ADDENDUM NO. 3
TO GENERAL, MECHANICAL AND ELECTRICAL
ABERDEEN PUBLIC WORKS
MAINTENANCE BUILDING
ABERDEEN, SOUTH DAKOTA

Addendum Dated: March 23, 2026

Original Plans and Specifications Dated: February 20, 2026

1 UNDERFLOOR PLUMBING PLAN - AREA F - ALTERNATE #1
1/8" = 1'-0"

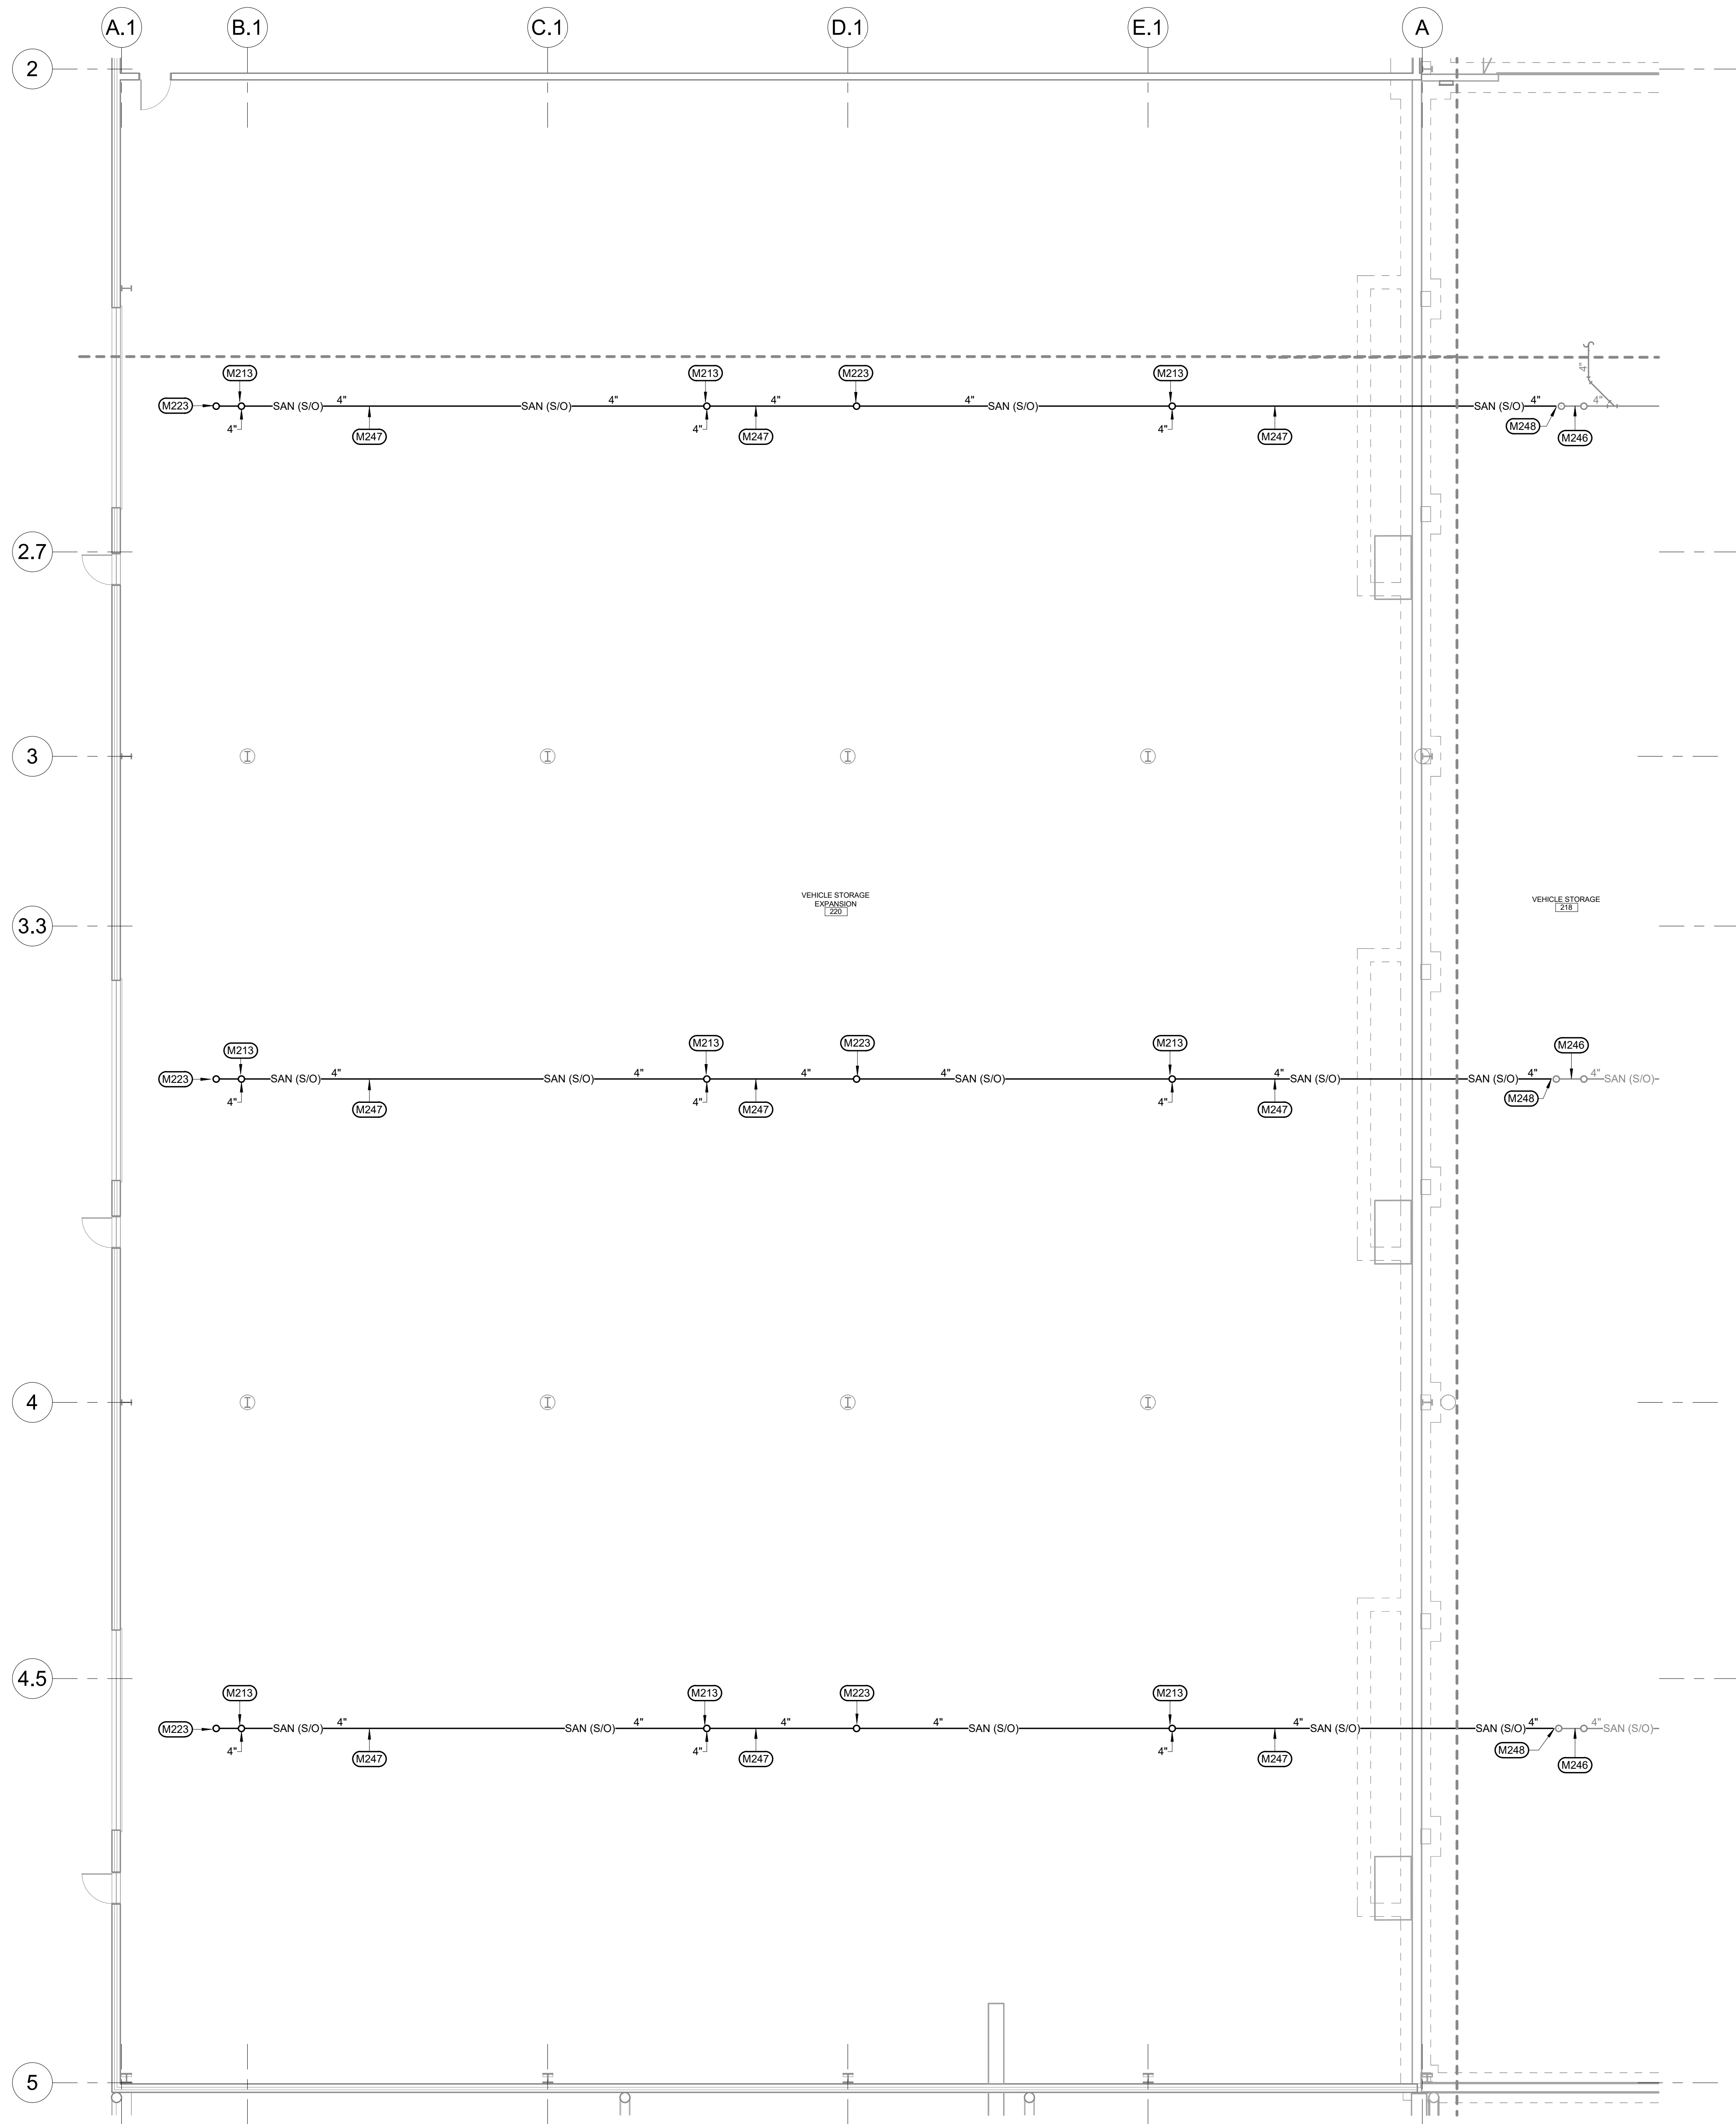
- 1. See attached sheet for the following revisions:
 - a. Note added to help clarify alternates.

1 FIRST FLOOR HVAC PIPING PLAN - AREA E - ALTERNATE #2
1/8" = 1'-0"

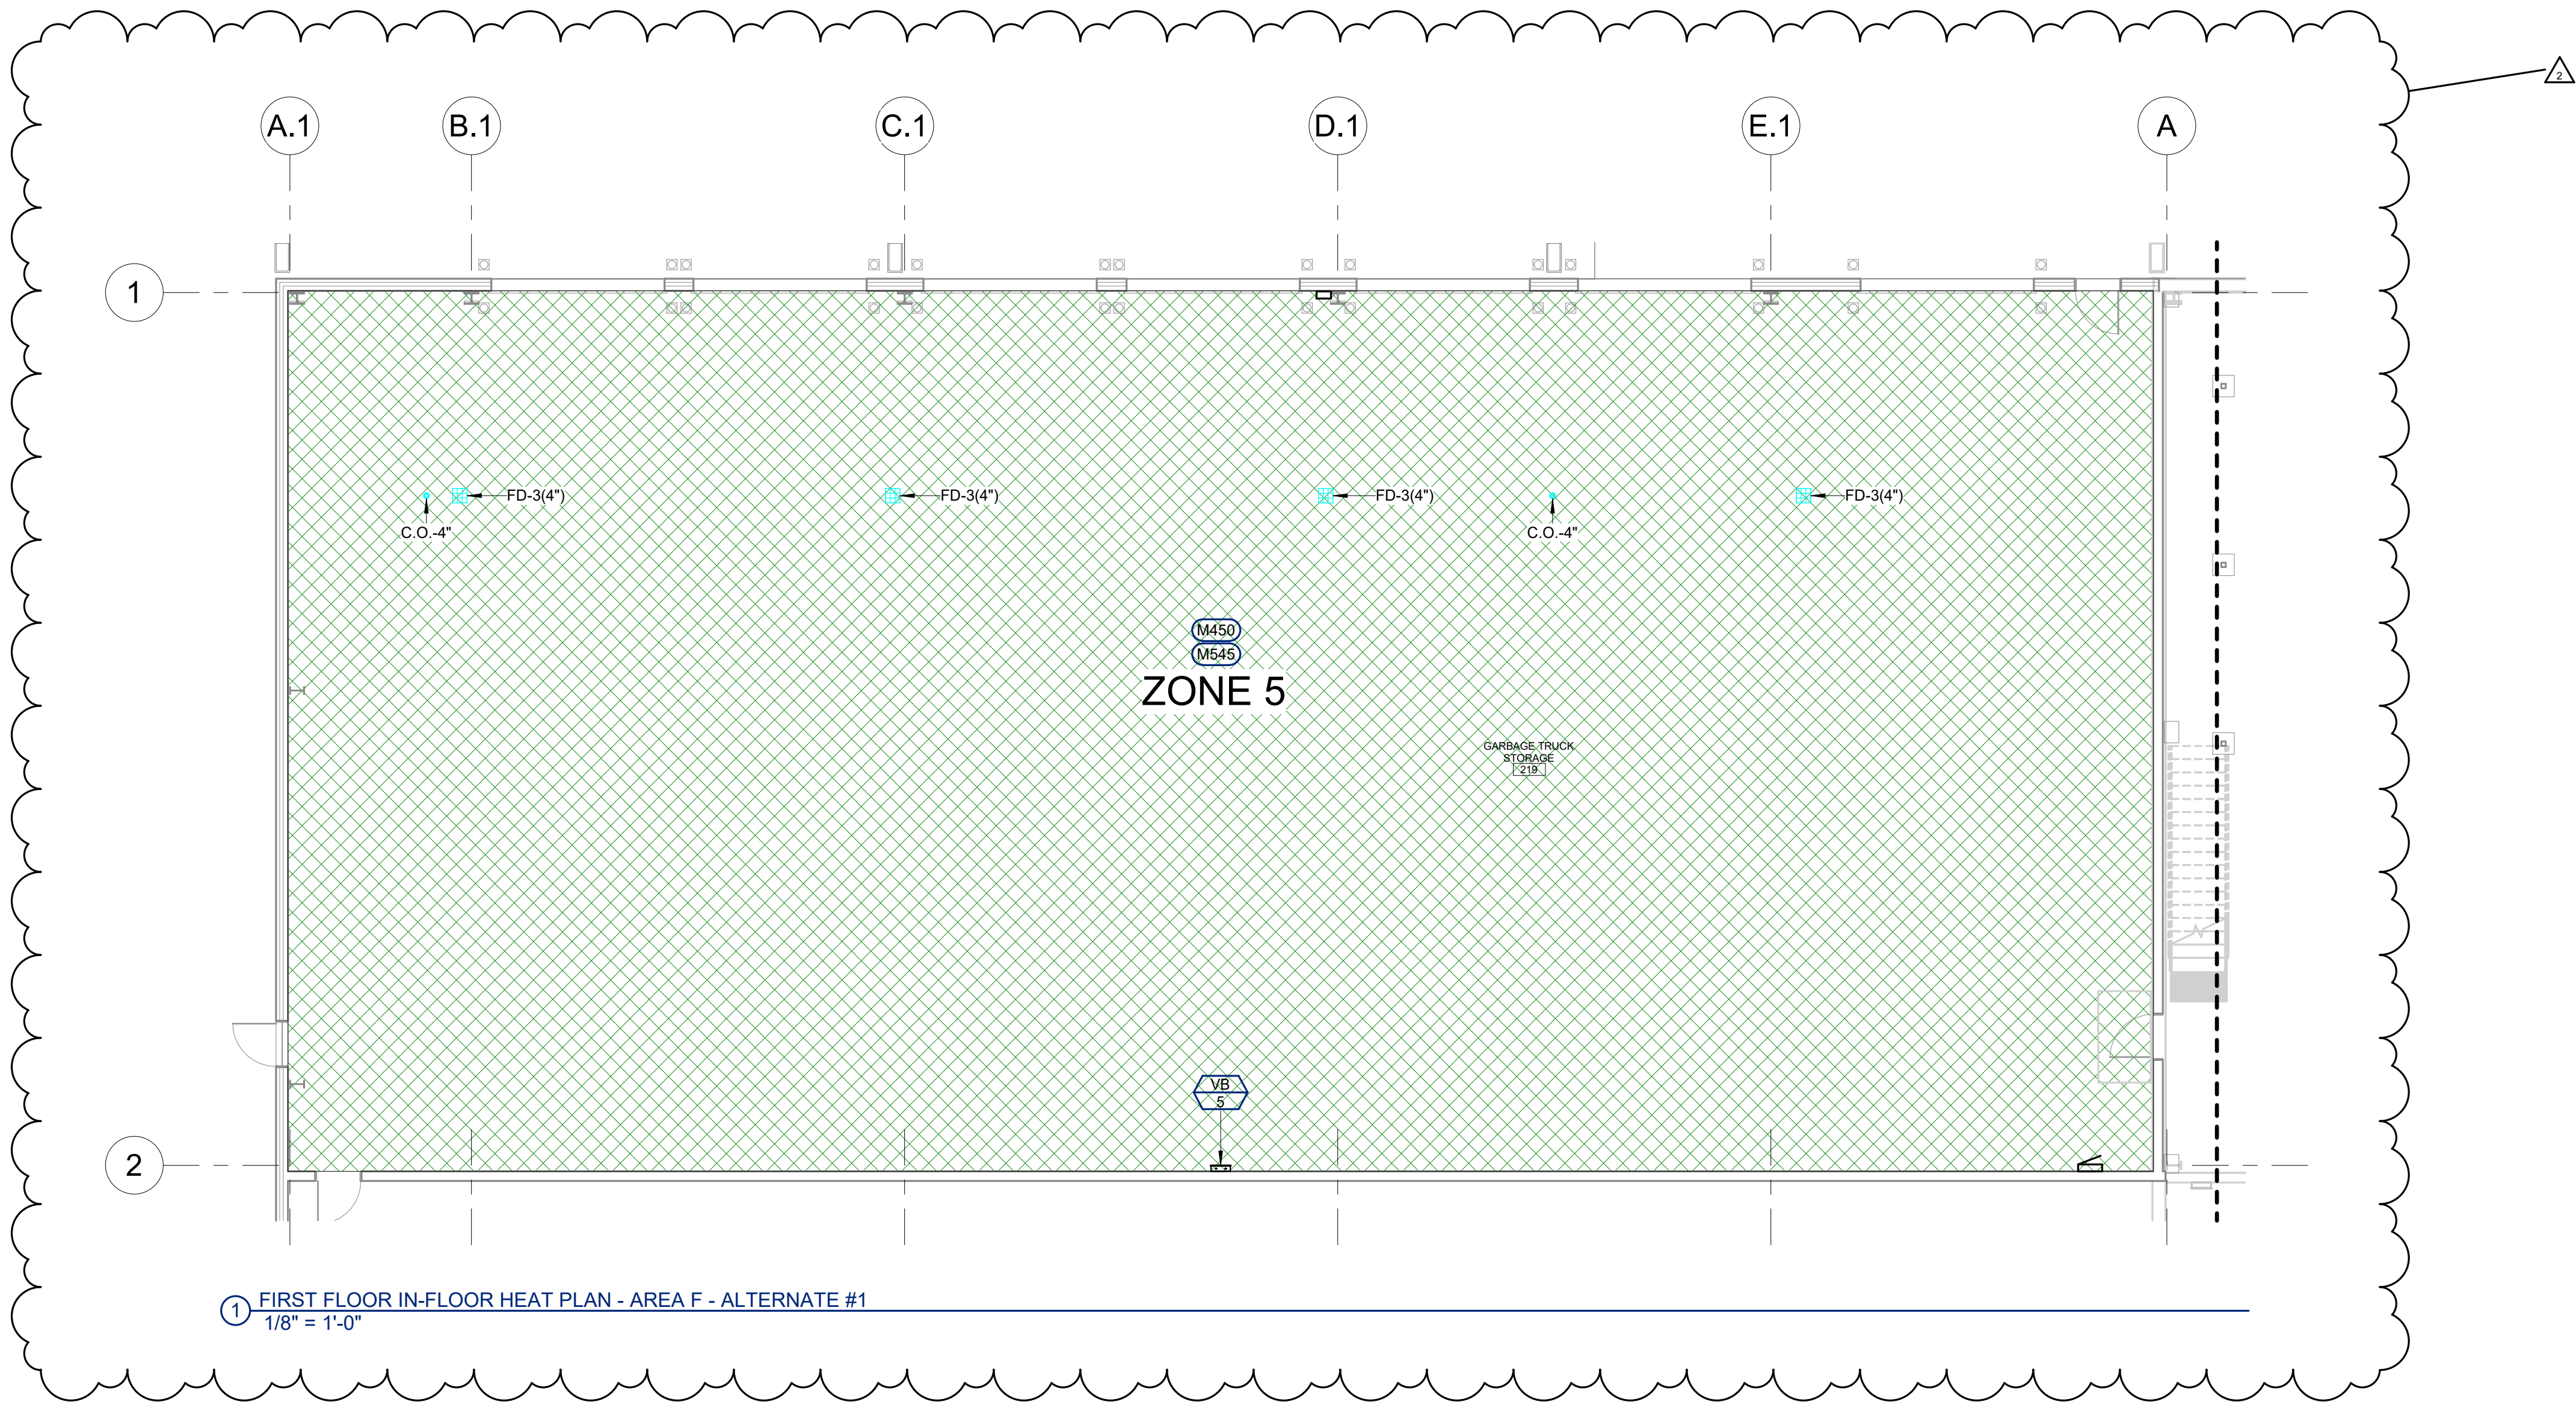
- 1. See attached sheet for the following revisions:
 - a. Note added to help clarify alternates.
 - b. HWS/R piping modified and pipe sizes and keynotes added for clarification.

8 BOILER INTAKE/VENTING DETAIL
NO SCALE

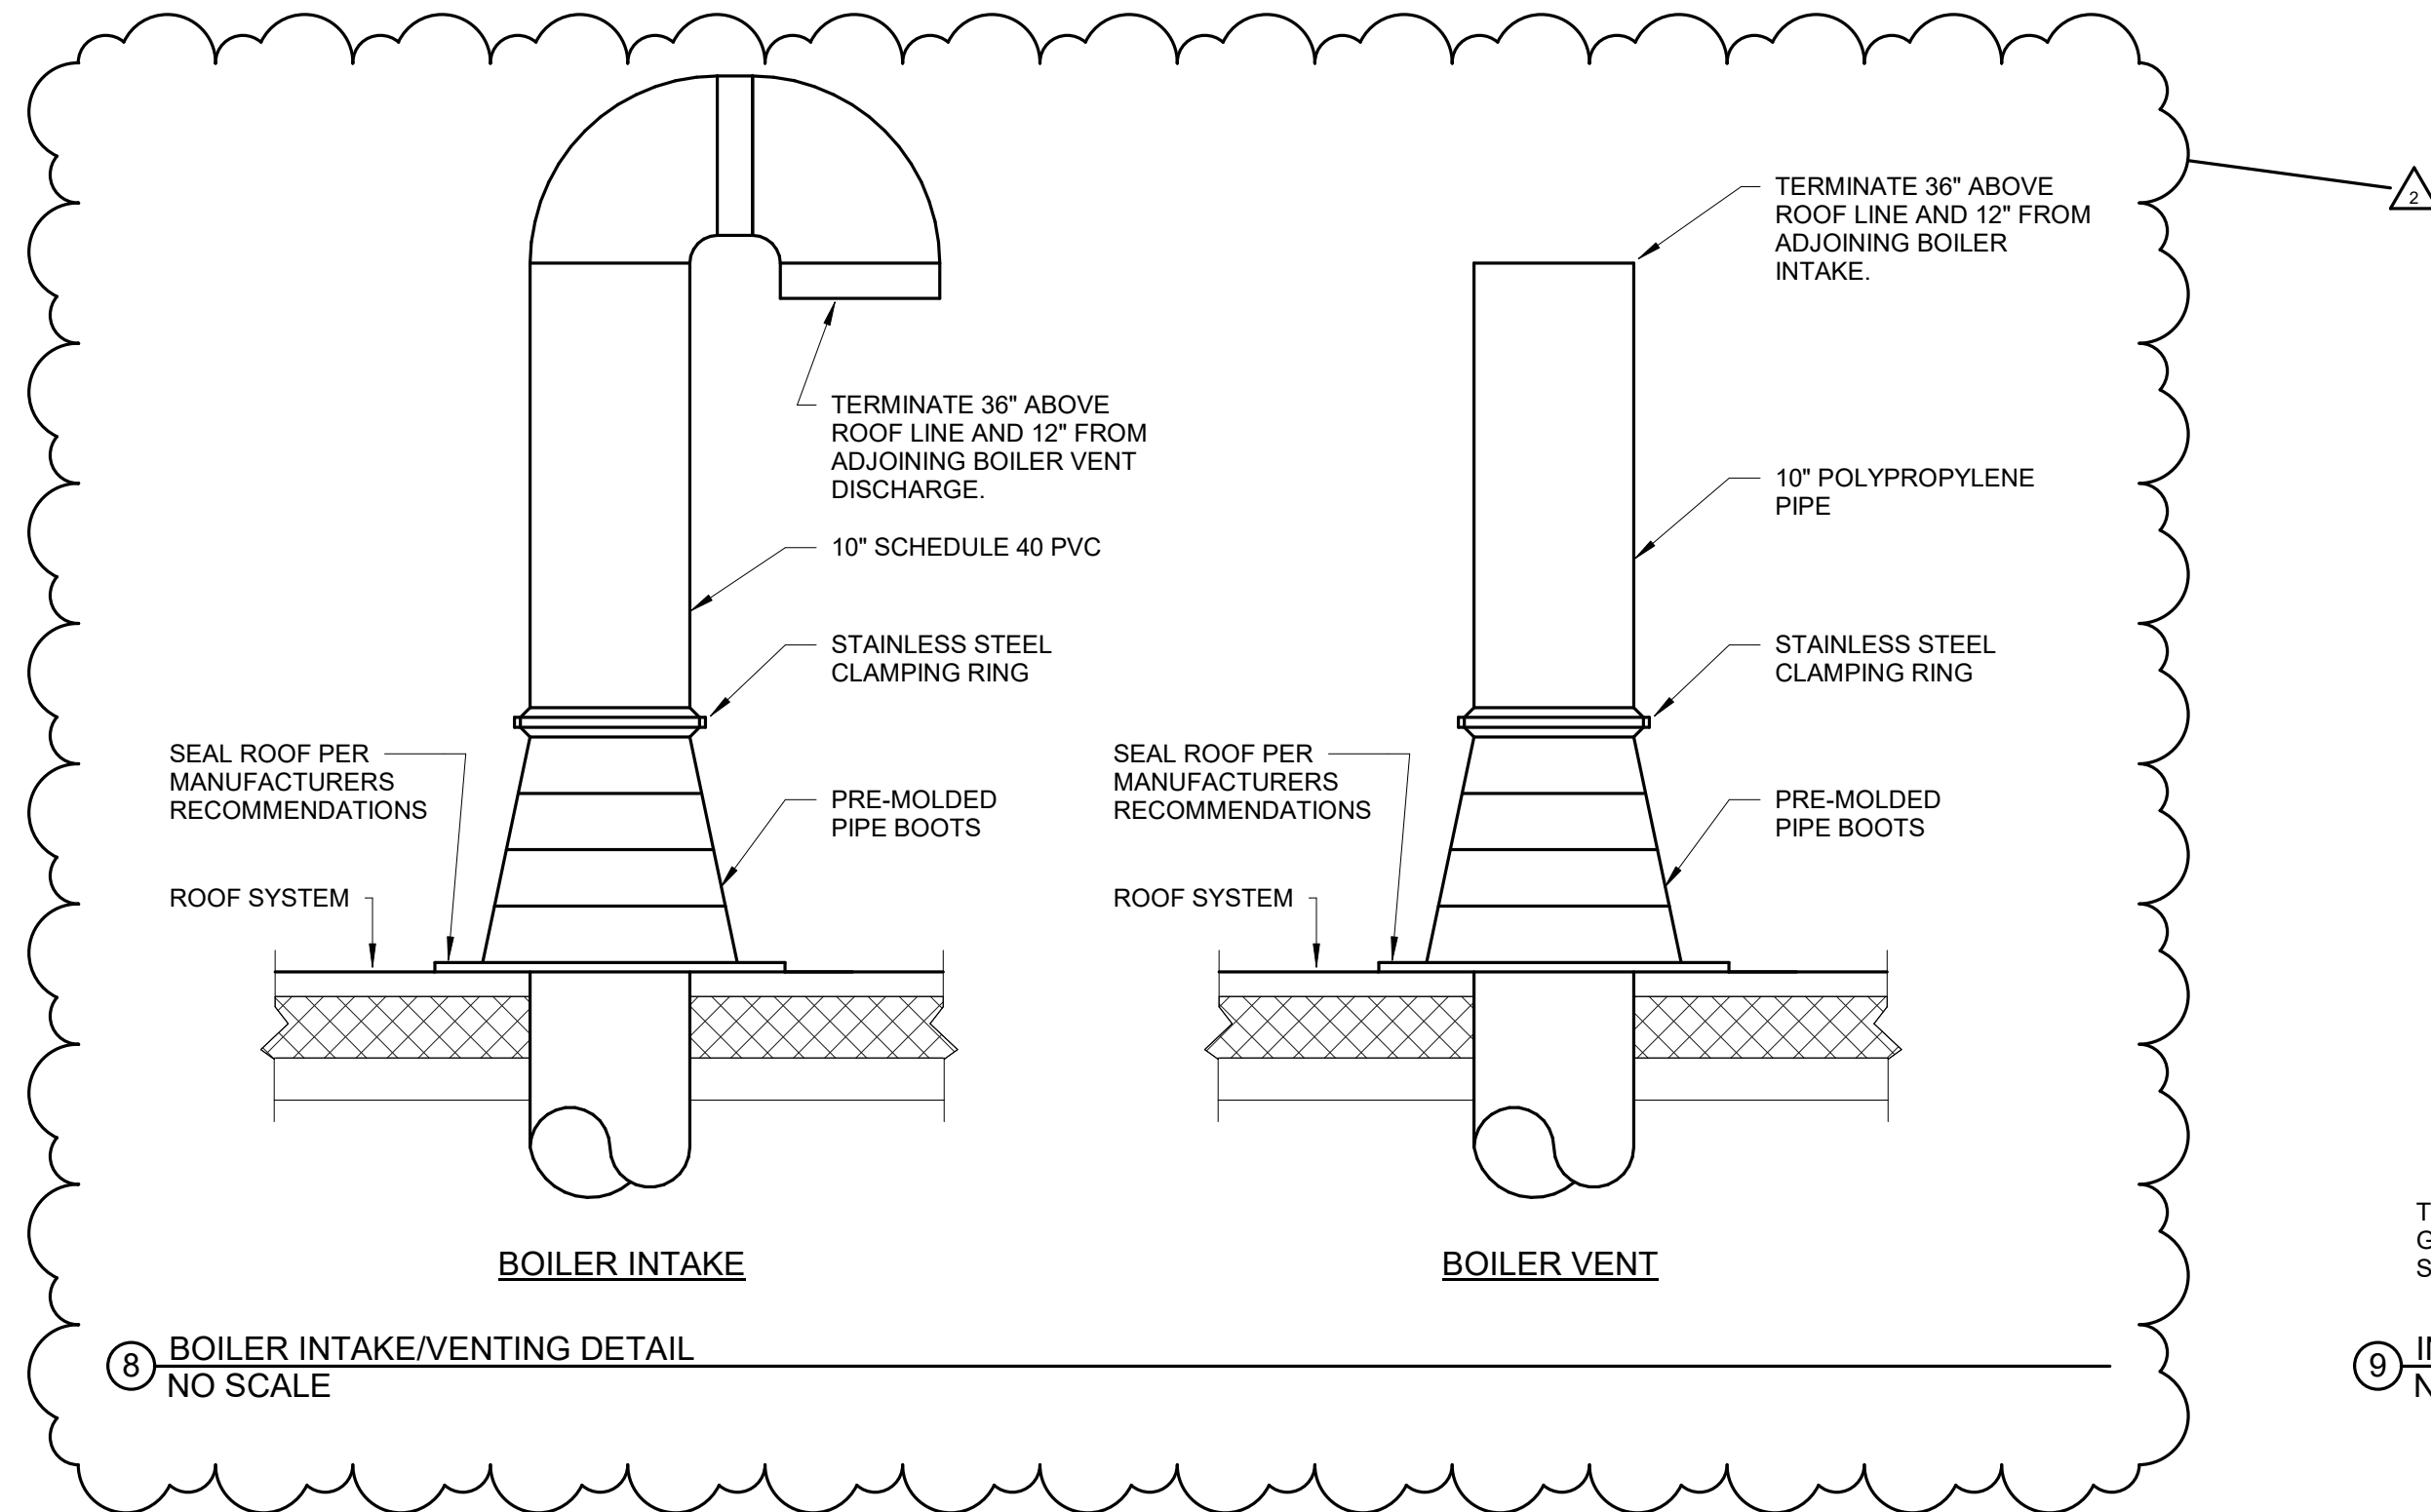
- 1. See attached sheet for the following revisions:
 - a. Sizes updated in Boiler Intake/Venting Detail
